Product hierarchy no. *				Part no.	SBU	Type / Description	Customer part no.
SBU	PG	PGU	Type				
02	007	012	0000001400	6610.XXXX	Connectors	6610

6610 new Cover					0118.2112	
creation date	created by	release date	released by	notification no.	revision	page
2012-06-08	sha	2012-08-21	sha	23633	-	1 of 1

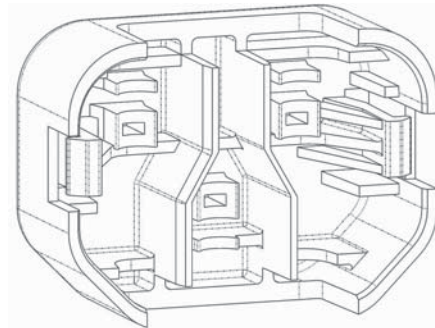
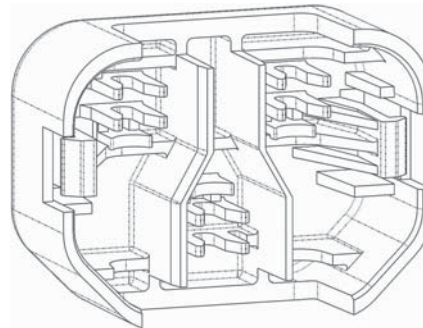
To ensure the fixation of the wires, especially for smaller size of conductor, a support on the Cover is necessary.

The fixation is visible only from the inside of the Cover.

The change gives security if smaller sizes of conductors are used.

Form: Fixation on the Cover
Fit: n/a
Function: Fixation of smaller conductors
Production Site: n/a
Product Label: n/a
